Lead Local Flood Authority

RE: DM/26/0682 – Land At Hurst Farm, Hurstwood Lane, Haywards Heath, West Sussex

This is a Reserved Matters Application Pursuant to Outline Planning Permission Mid Sussex District Council (MSDC) Reference: DM/25/1630, Lewes District Council (LDC) Reference: LW/2510707 at Hurst Farm, for appearance, layout, scale and landscaping only.

Phase 1:

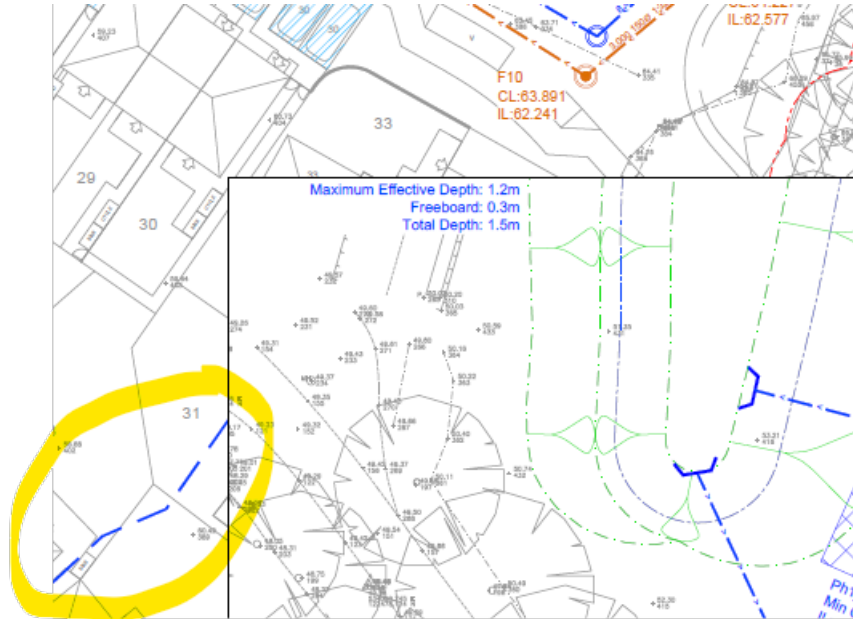
1. Due to the location of the inset on Sheet 2 of the Phase 1 drainage plan, we are unable to review where the surface water sewer is draining. In addition, the proposal to locate a surface water sewer in homeowners' private gardens may create maintenance issues.

2. Please can the basin details for Phase 1 be added to the drawing, as currently we have 2 clipped sections of supporting text. This means we cannot check for correlation with the hydraulic calculations.

Phase 2:

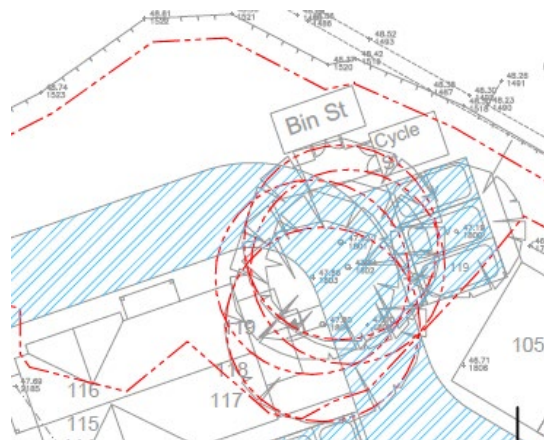
1. While not directly within our remit, we have noticed that there appears to be root protection areas in the same location as proposed permeable paving.

Phase 3:

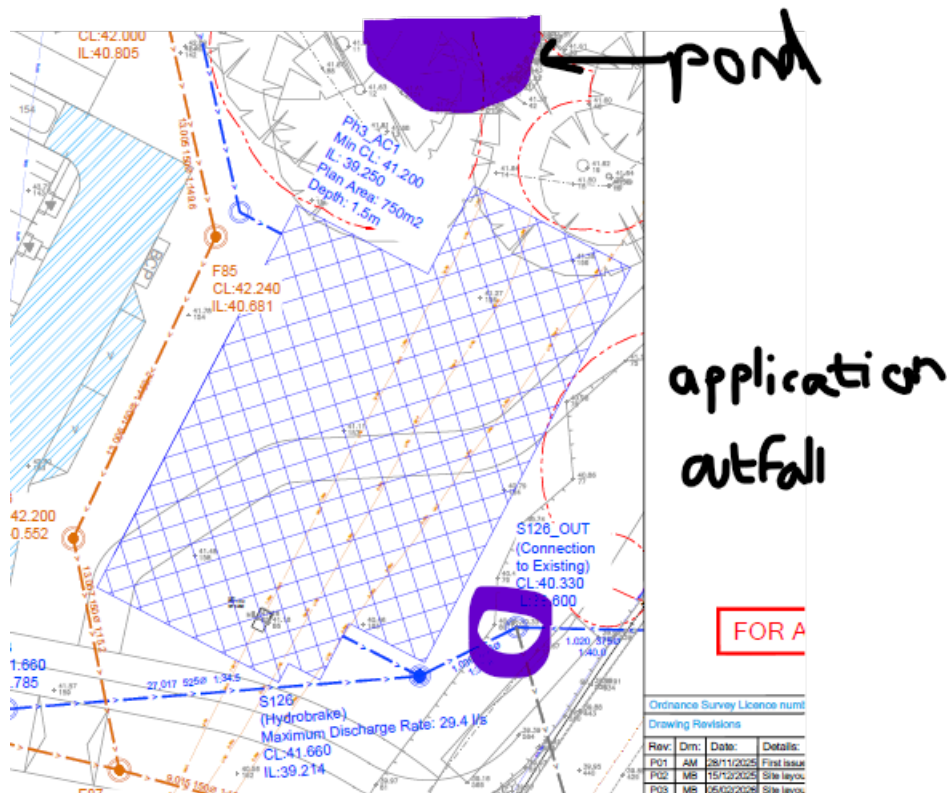
1. Further investigations into the existing pond and any outfalls are required. This is to ensure that the existing network can be maintained, and that there are no clashes between the proposed tank and the proposed outfall to the existing culverted watercourse.

2. With regard to paragraph 2.19, we require additional information as to what the site constraints are. For avoidance of doubt, a lack of space is not an adequate reason to replace an open basin with an underground, traditional tank.
